## **Additional Information Request # 8**

### ***Groundwater Seepage from the PSMF and MRSA***

CEAR #550 (Natural Resources Canada)

Figure AiR 8-1: Schematic illustrating the overall water balance for the MRSA and flows to the open pit and Catch Basins.

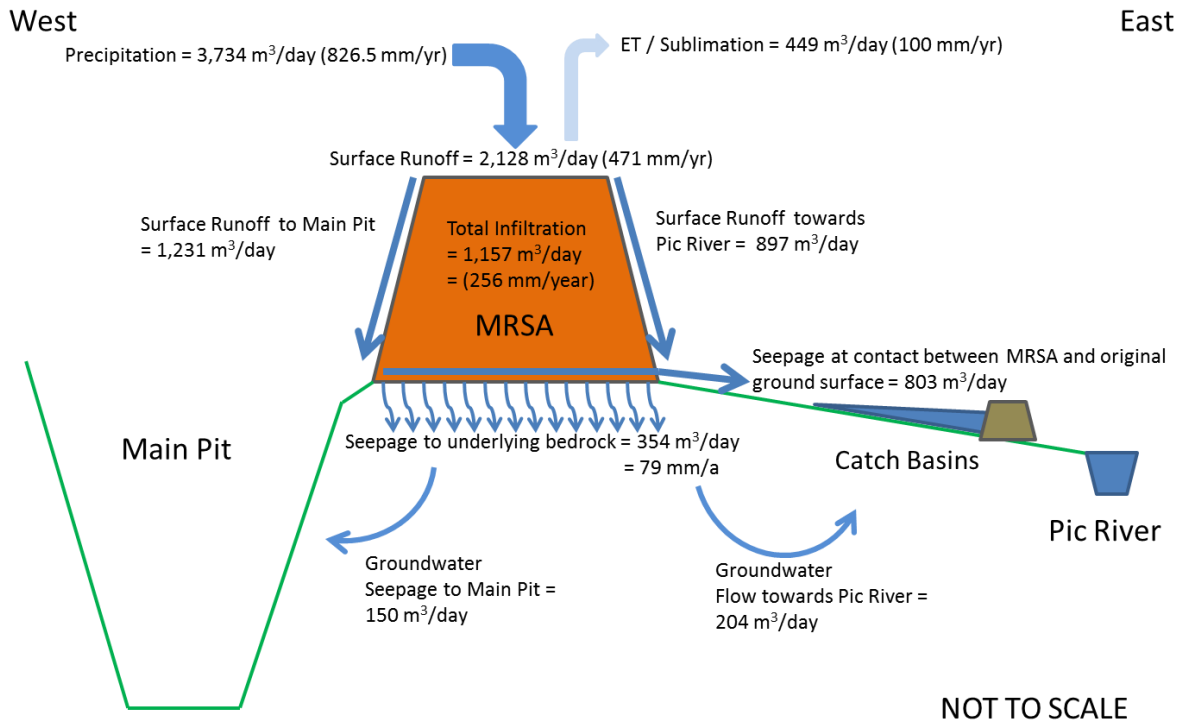
In its review of SCI's response to IR 24.15, Natural Resources Canada noted that additional information is needed to assess the accuracy of the values presented in Tables B and C (IR 24.15), which it considers important in the technical review of the information related to groundwater, particularly as the values in these tables provide the basis for determining estimates for COPCs in surface water receptors.

- Specify the rate of seepage used in the calculation of MRSA seepage loadings (Table B); and
- Discuss the appropriateness of the seepage rate used, including reference to specific sections and page numbers of the EIS.

Figure AiR 8-1 illustrates the components of the water balance for the MRSA that includes seepage of contact water from the rock stockpile that flows along the natural ground to the catch basins and the seepage into the natural ground below the MRSA that becomes groundwater. The values on schematic in Figure AiR 8-1 show that the components of flow of contact water as surface runoff represents about 1,700 m<sup>3</sup>/day (897 runoff + 803 seepage) while the groundwater component representing contact water is only about one-eighth of the surface component or 204 m<sup>3</sup>/day. The surface water flow component was developed using reasonable and conservative representations of components for a mine rock pile. The groundwater seepage component was developed from the MODFLOW groundwater model for the appropriate hydrogeologic conditions at the site and the respective flow conditions represented by the open pit to the west and Pic River to the east as discussed in SID 15 (TGLC, 2012).

STILLWATER CANADA INC.	
MARATHON PGM-Cu PROJECT	
<b>PROCESS SOLIDS MANAGEMENT FACILITY SEEPAGE CONDITIONS FOR TYPICAL EMBANKMENT CROSS-SECTION</b>	
<b><i>Knight Piésold</i></b> CONSULTING	P/A NO. NB101-446/5
	REF. NO. NB14-10
<b>FIGURE AIR 8-2</b>	
REV 0

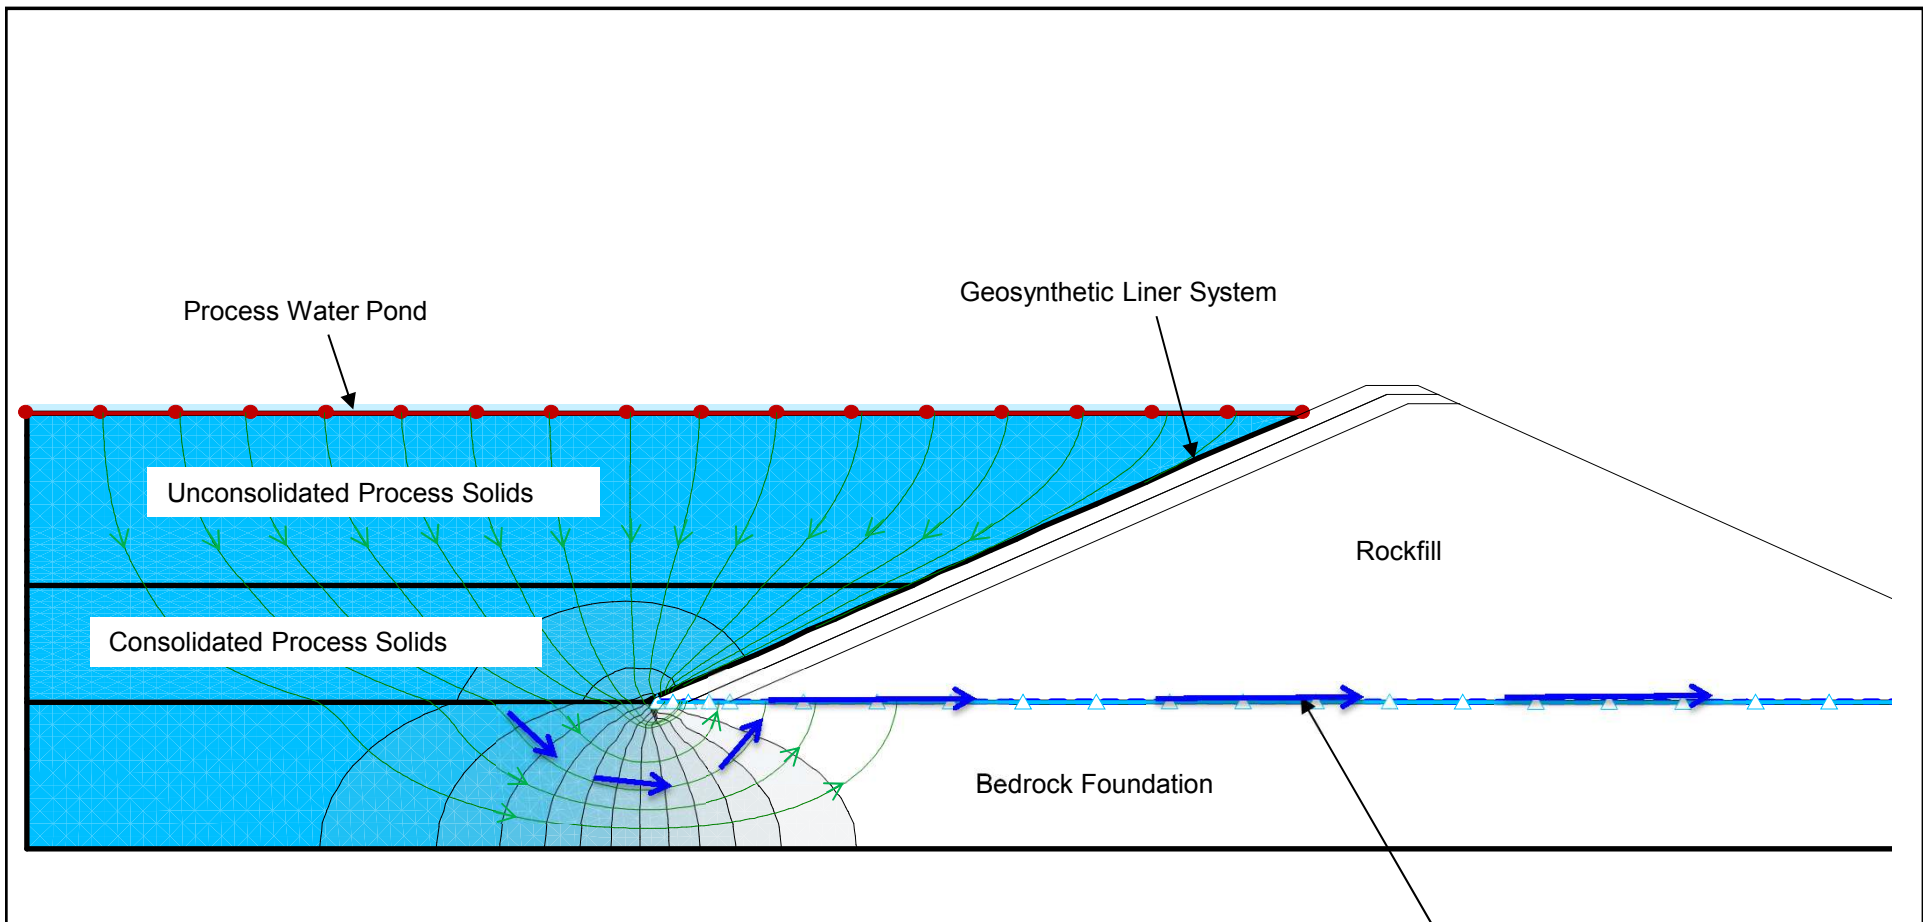
Per Table C, IR 24.15, "Maximum Loadings from PSMF Seepage to Receiving Surface Waters":

- Specify the rate of seepage from the PSMF used in the calculation of values in Table C; and
- Discuss the appropriateness of the seepage rate used, including reference to specific sections and page numbers of the EIS.

The seepage rates from the PSMF used to calculate the mass loadings presented in Table C of IR 24.15 were derived from the results presented in the Knight Piesold memorandum NB13-00080; entitled "Process Solids Management Facility Seepage Analysis" (dated June 10, 2013, attached). The majority of seepage from the PSMF will occur to the base of the perimeter embankments (refer to Figure AiR 8-2), and the above-noted memorandum outlines the modelling approach and assumptions used to estimate these rates. The values presented in Table C of IR24.15 are from Year 12 of operations and are conservative representations of conditions post-closure. The seepage values used in the response to IR 24.15 are as follows:

The estimated seepage rates account for seepage through the bedrock to the base of the perimeter embankments, as well as potential defects in the HDPE geomembrane that will be installed on the upstream face of the embankment. The HDPE geomembrane will be connected to the prepared bedrock foundation via a concrete plinth. The seepage model accounts for foundation grouting, the proposed embankment construction method and process solids material parameter values from laboratory test work. The material parameter values used in the model are summarized in the seepage analysis memorandum noted above (KP Memorandum NB13-00080).

Seepage from the PSMF reports to the original ground surface within the rockfill embankment foot print and flows towards the downstream toe of the embankment
